## PLANNING & ZONING COMMISSION

TO: Michelle Eddy, CMC/CPM - Town Manager/Clerk  
FROM: Kyle Parag, Plan Reviewer - CAA  
DATE: March 16, 2023  
RE: Planning/Zoning/Architectural Guidelines review –  
0033 Golden Crown Ln

TO: Michelle Eddy, CMC/CPM - Town Manager/Clerk  
 FROM: Kyle Parag, Plan Reviewer - CAA  
 DATE: March 29th, 2023  
 RE: Planning/Zoning/Architectural Guidelines review –  
 0066 Conifer Dr

**TO: Michelle Eddy, CMC/CPM - Town Manager/Clerk**  
**FROM: Thomas Marshall, Plan Reviewer - CAA**  
**DATE: May 31, 2022**  
**RE: Planning/Zoning/Architectural Guidelines review –  
0066 Conifer Drive**

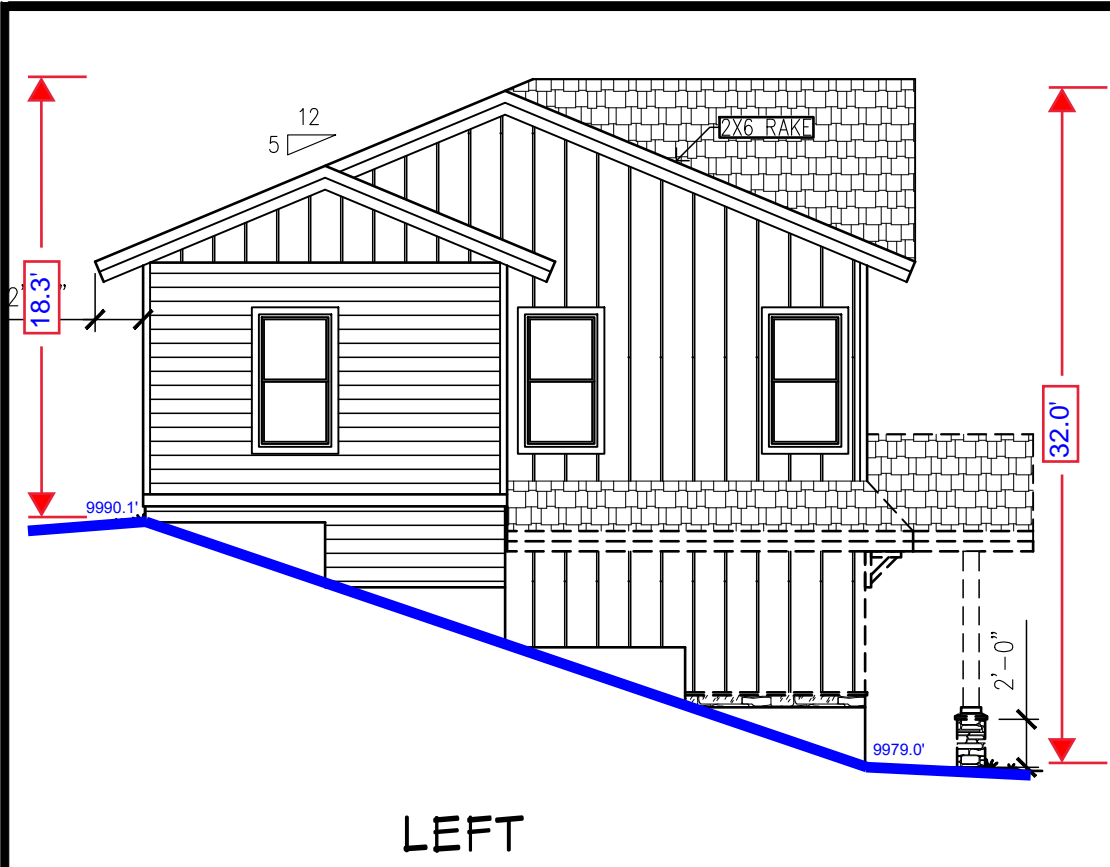
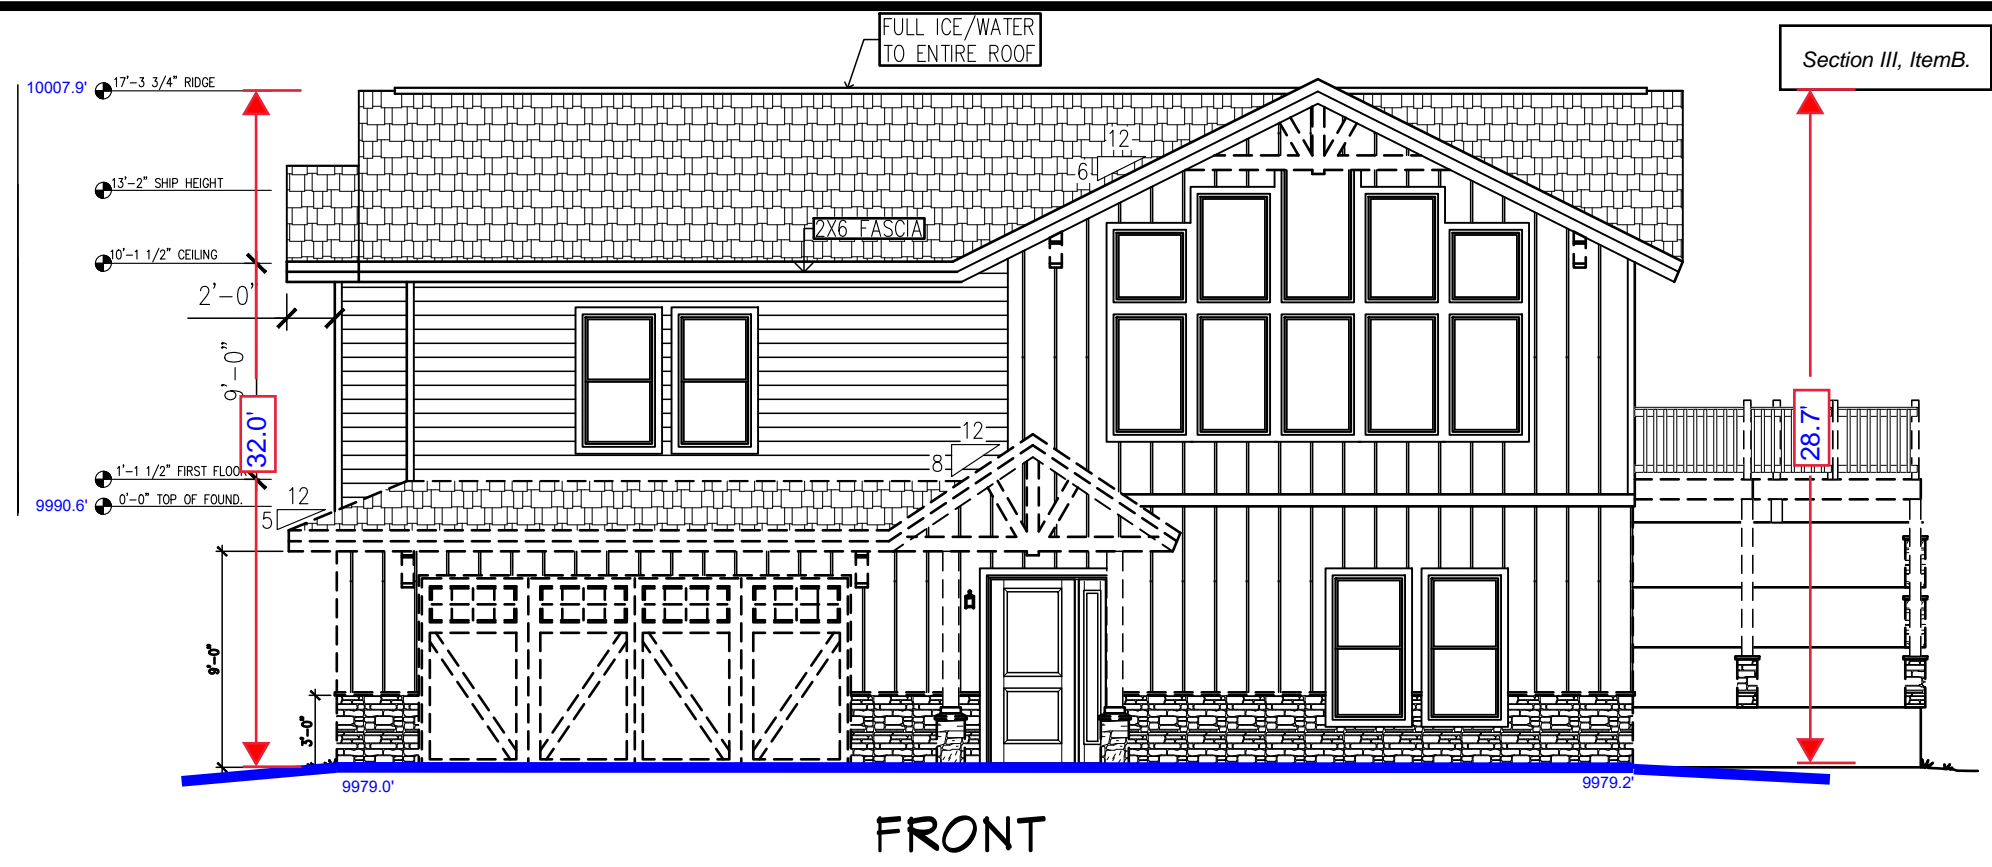
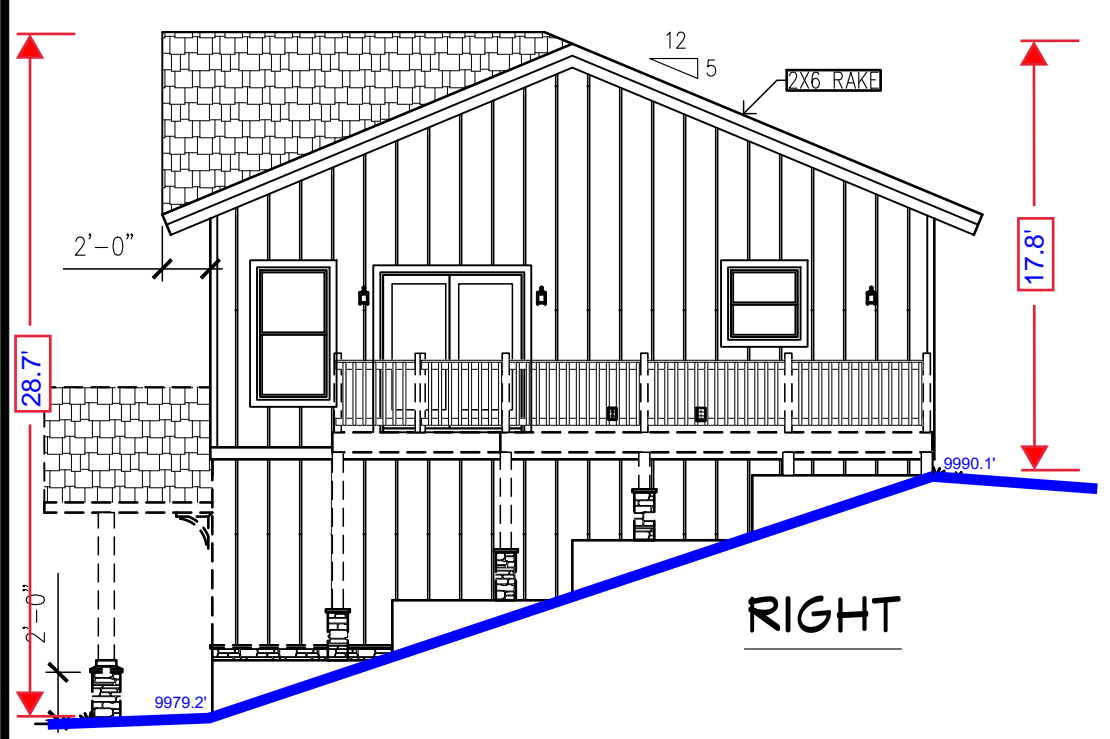
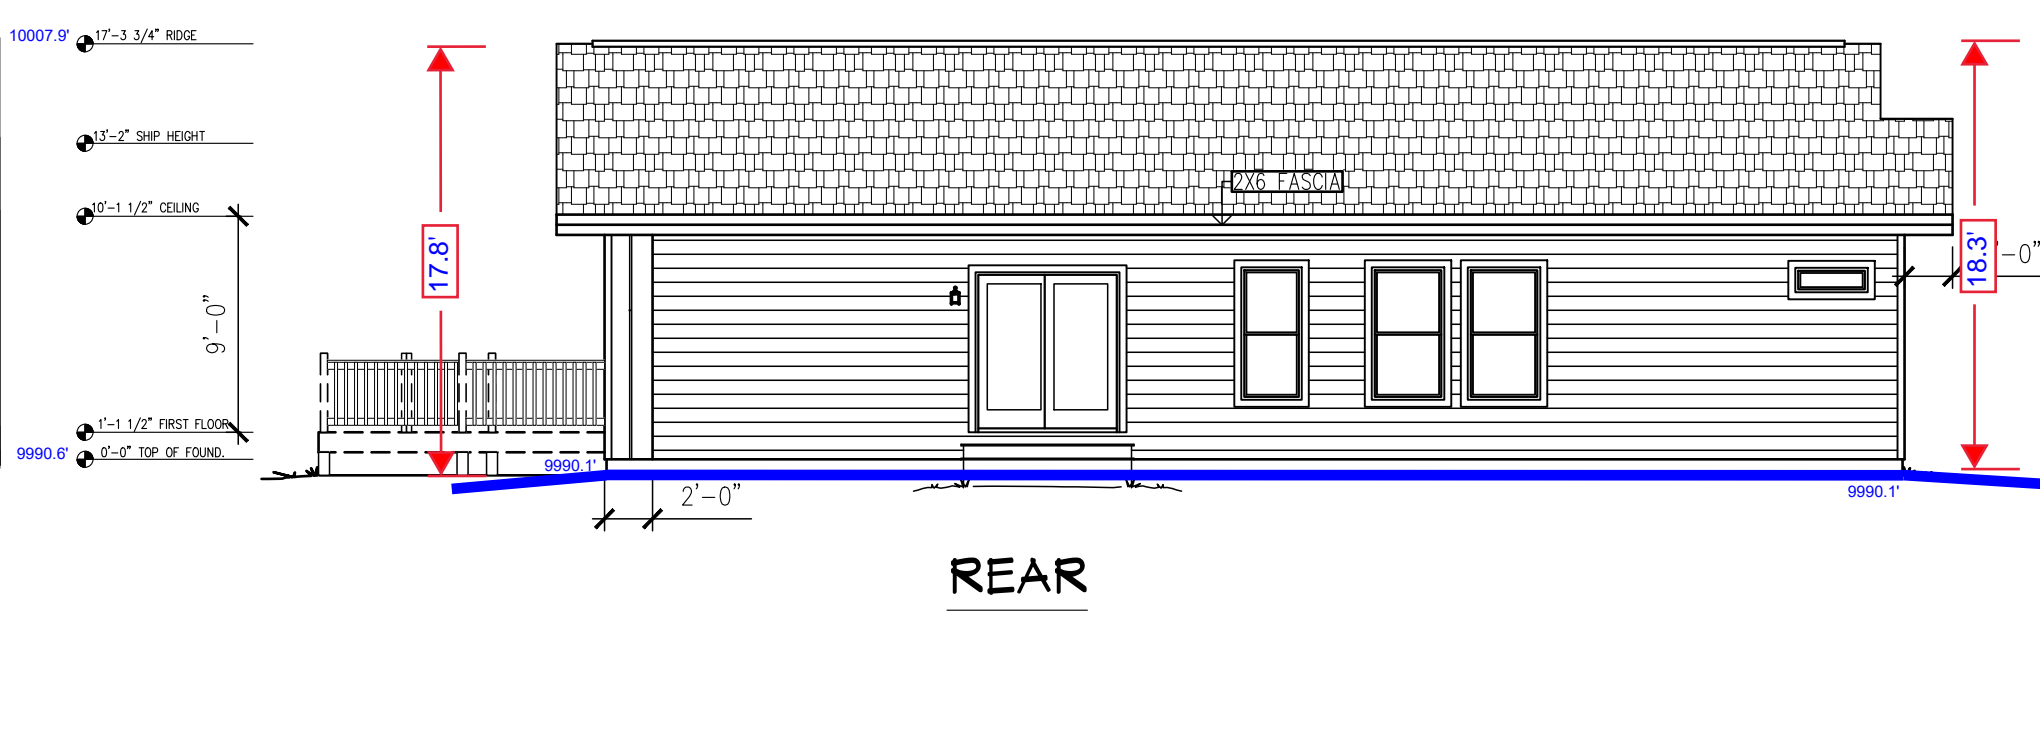
<p>The snow storage calculations are provided outside of the driveway area. Snow storage shall be calculated on improved driveway surfaces.</p> <p>Driveway exceeds the maximum 6% in the first 20 feet and 10% slopes elsewhere, and drawn at 12%, the maximum allowable with Town approval.</p> <p>Driveway width is scaled at 16 ft, exceeding the maximum of 12”</p> <p>Culvert is indicated and appears compliant.</p>	
VI. F. Parking / Garages	The proposed attached two vehicle garage and the additional exterior parking space complies.	Y
VI. G. Exterior Equipment and Satellite Dishes	No exterior equipment is indicated	Y
VI. H. Easements and Utilities	<b>Lodestone tr is indicated to presently extend beyond the easement indicated. Lodestone Tr is currently used as a private drive for 0041</b>	Y
VI. I. Recreation Facilities	No facilities are proposed	Y
VI. J. Signage	Address marker/signage is not indicated on the drawings	Y

VI. K. Pathways /Walkways	No walking paths are proposed	Y
VI. L. Wetlands	No wetlands are identified on the plan.	N/A
VI. M. Wildfire Regulations	Many of the required regulations are operational requirements post-construction.	Y
<b>ARCHITECTURAL GUIDELINES</b>		
VI. B. Building Forms	Proposed foundation walls merge with the existing grade. <b>Elevation Designs suggest exposed concrete foundational walls on the sides of the home and are not permitted.</b> Base mass intent is not designed on rear of home, as the main siding materials (composite) are indicated to near grade. Snow shedding will be a problem in front of garage area.	N

VII. C. Setbacks	The proposed structures sit within the required setbacks per the submitted site plan.	Y
VII. D. Building Height	Building complies with zoning district requirements.	Y
VII. E. Roofs	Gabled roof with a slope of 5:12 is proposed. Material is proposed as a charcoal black asphalt shingles	Y
VII. F. Exterior Wall Materials	Proposed exterior materials are composite wood look siding material in “cavern steel” dark grey.	Y
VII. G. Exterior Trim	Proposed trim colors are black in color, and elevations indicate an appropriate sizing	Y
VII. H. Windows and Doors	Windows, doors, and garage doors are proportional to the structure and appear in general compliance.	Y
VII. I. Balconies and Railings	Railings are traditional in appearance and complement the structure. In general conformance.	Y
VII. J. Chimneys and Roof Vents	<b>An indoor fireplace is proposed. Neither the chimney nor a roof vent is identified. Please indicate if this fireplace is vented out the side of the home, or through the roof. If through the roof, please provide enclosure material or indicate the painting of the vent extension to match the roof material.</b>
